Proposed rejection of Beckton sub-option: Beckton to KGV direct pipeline from the London Reuse SRO programme

I am writing on behalf of Thames Water's London Reuse SRO regarding the proposed rejection of a Beckton sub-option; the Beckton to KGV direct pipeline from the London Reuse SRO programme.

Beckton Effluent Reuse Schematic

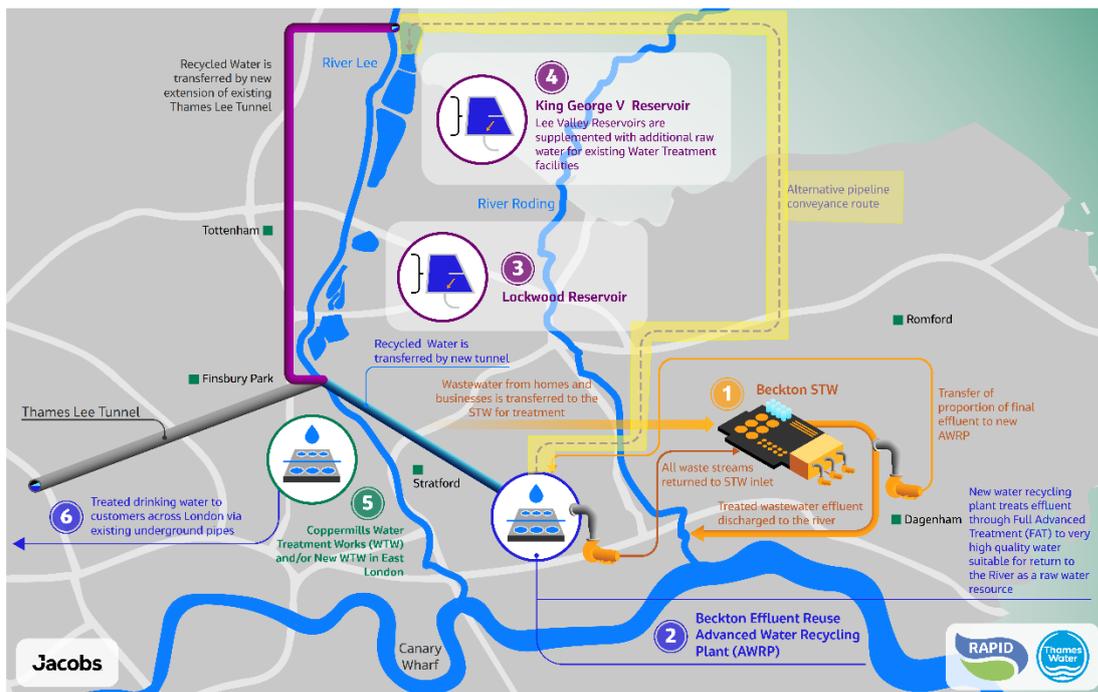
1. A combination of a tunnel from the proposed Beckton Advanced Water Recycling Plant (AWRP) to Lockwood and a tunnel from Lockwood to the discharge into the River Lee Diversion, upstream of King George V Reservoir (KGV). Capacity of the tunnel would be sufficient to transfer up to 300 MI/d recycled water from Beckton AWRP (and allow transfer of Thames Lee Tunnel (TLT) flows from Lockwood up to KGV).
2. A pipeline option from the Beckton AWRP direct to the discharge into the River Lee Diversion upstream of KGV reservoir for a maximum recycled water transfer of up to 100 MI/d. There is no routing via Lockwood nor the option to provide additional capacity for TLT flows. See highlighted yellow route in the map schematic below.

The direct pipeline conveyance sub-option was introduced at Gate 1 to confirm whether a smaller and potentially cheaper capacity conveyance would make a smaller Beckton Reuse scheme (e.g. sub 100 Ml/d capacity) more cost viable, in comparison to a smaller Beckton Reuse scheme with a tunnel option. This alternative conveyance option was submitted for WRSE regional modelling and to date this modelling has chosen the tunnel conveyance instead of the pipeline conveyance under all scenarios. Therefore, it has been demonstrated that this sub-option is not cost effective when compared to the tunnel.

During Gate 2, engineering and environmental refinements have been carried out to further understand and develop the pipeline sub-option. Material changes have been identified over the last six months that when assessed through the WRMP19 feasibility screening criteria assessment results in the sub-option being deemed not viable on a number of grounds and not a cost-effective solution.

A number of planning conflicts have been identified between the proposed pipeline alignment and existing land uses, along with policy designation conflicts. This results in greater risks and affects the WRMP19 feasibility assessment criteria for: "Planning Policy Designations"; "Land take and land quality"; and "Non-traffic construction impacts". In several key areas it has been identified that trenched construction would not be appropriate due to these land use conflicts, for example:

Through scheme refinement the AIC costs have increased by ca. 30% from Gate 1 and further refinement is likely to increase this further as a result of mitigating a number of the additional planning constraints identified above and considering the operational complexity of a pressurised pipeline.

Our current estimated AIC for the 100 Ml/d pipeline sub-option is £1.8/m³ (up from £1.4/m³ at Gate 1) This is significantly higher than for the 300 Ml/d tunnel conveyance sub-option at £1.6/m³ and would result in a red RAG status scoring for "Normalised Cost/AIC" for the 100 Ml/d pipeline sub-option.

There is significant engineering complexity involved with the construction of a 32km, 1m diameter pipeline through urban, rural, environmentally-protected and recreational land areas. The pipeline design at Gate 1 was proposed to be largely trenched (open-cut) to save on costs of trenchless pipe-lay, but owing to the increase in trenchless construction combined with some remaining trenched construction in more rural areas the construction complexity has increased. The feasibility assessment criteria for the "Construction Complexity" would result in a red RAG status.

We are therefore seeking agreement to formalise the removal of the Beckton pipeline sub-option from the London Reuse SRO Gate 2 scope based on the reasons enclosed. This would also serve to prevent further unnecessary Gate 2 expenditure progressing a sub-option deemed not viable or cost effective when compared to a tunnel option.
